STANDARD FIELD SERVICE BULLETIN

FSB Number	CHRAEFSB2016-22
Author	Tony Bryan
Date	06/28/2016
Subject	Moto G4, Moto G4 Plus - Side-Key Tactile (Stuck Keys)
Model Affected	XT162x, XT164x
Level Of Repairs	Level 2

Figure 1.0 - Example Stuck Side-Key

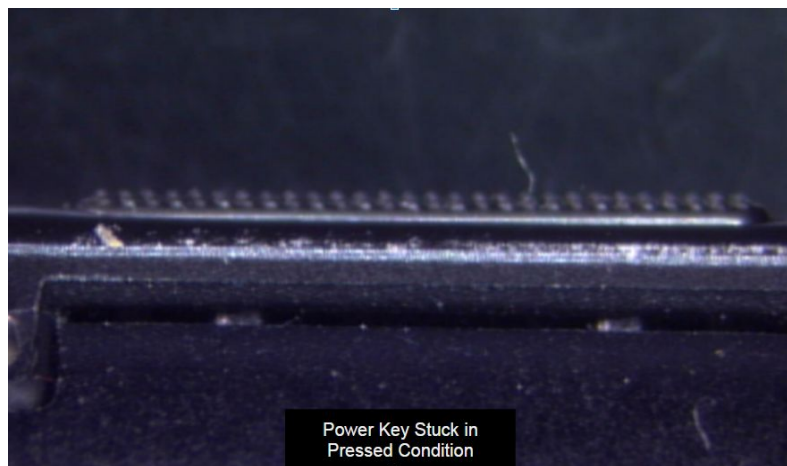
Motorola is aware of a potential customer experience issue on the Moto G4 and Moto G4 Plus products related to Side-Keys. Some users reported experiencing poor tactile feel and/or stuck side-keys on their Moto G4 device. See Figure 1.0 below.

Engineering analysis determined the issue was caused by improper alignment between the side-key buttons and the SMT switches on the PCBA.

Figure 2.0 - Side-Key Kapton Shim Placement

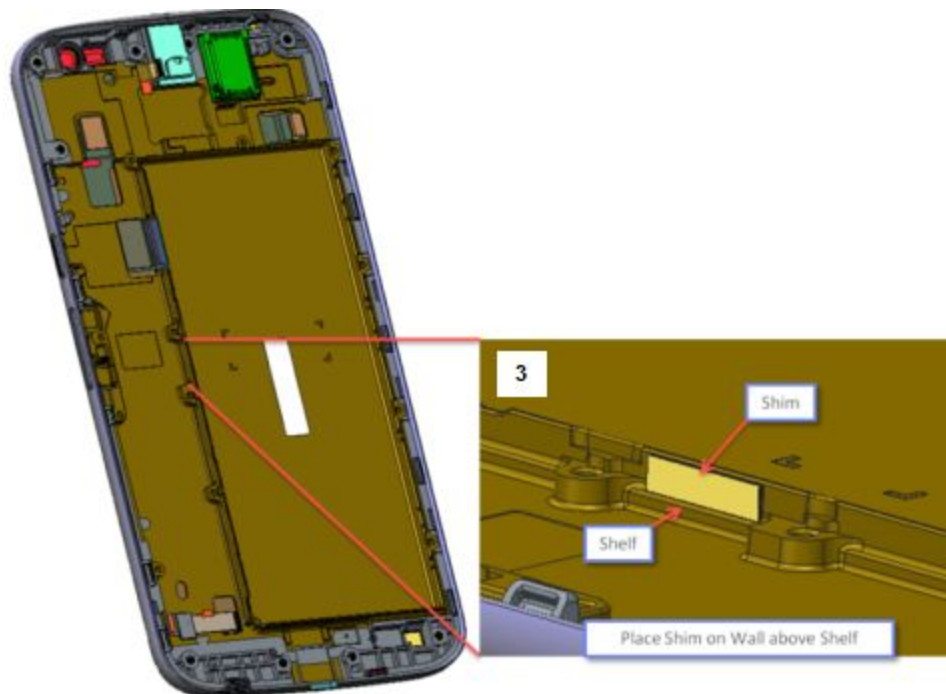
As of 5/31/16, the factory added a Side-Key Kapton Shim (p/n: 11018240001) to the Assembly Process to help better align the side-key button plungers to the SMT switches on the PCBA. See Figure 2.0 below.

Note: Shim must sit above shelf of housing wall and must be hand pressed to achieve good wetting on housing surface.

1. Inspect for and place if necessary the Side-Key Kapton Shim (p/n: 11018240001) prior to reassembly. See Figure 2.0 above.
